Amendment Report

Application for Licence Amendment

Licence Number L5245/1967/14

Premises Kwinana Alumina Refinery

Alcoa Kwinana RSAs and Landfill Cells

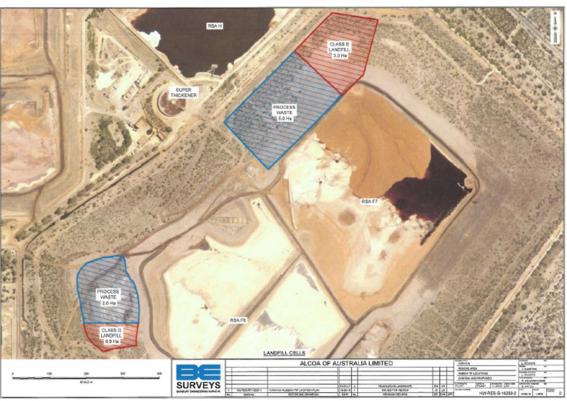
The existing Class II landfill cell is within Area F of the RSA; the Licence Holder is proposing to complete this cell and construct a new cell in Area F. The types and volumes of waste accepted in the landfill are not expected to change. The Delegated Officer considers that the location of a new cell in the same area will not change the risk profile of the Premises. The regulatory controls in the licence will continue to apply to the new area and are considered appropriate. Therefore, the Delegated Officer is satisfied that the current licence controls are sufficient and that no changes to the licence conditions are required other than to update the plan showing the location of the landfill in Attachment 2 of the licence.

- 5. The plan titled 'Alcoa Kwinana Landfill located within the RSAs' in Attachment 2 of the licence is replaced it with the plan titled 'Alcoa Kwinana RSAs and Landfill Cells' attached to this Amendment Notice.
